Radar PTZ Camera Firmware Version: V5.5.22

Release Note

(2021-04-14)

Firmware Basic Information	Firmware Version:	V5.5.22
	SDK Version:	HCNetSDKV6.1.6.15_build20201125
	Hik-Connect:	v1.5.60

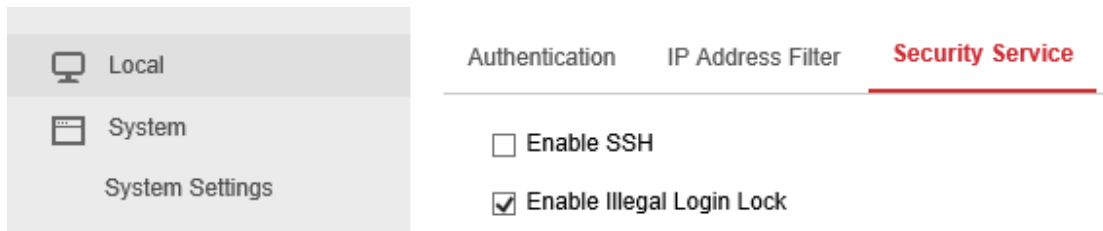
- Add target filter of radar event:

Support select Human, Vehicle, Other. Select neither of them by default, all the target could trigger the alarm.

NOTE: No double check mode cannot use the target filter.
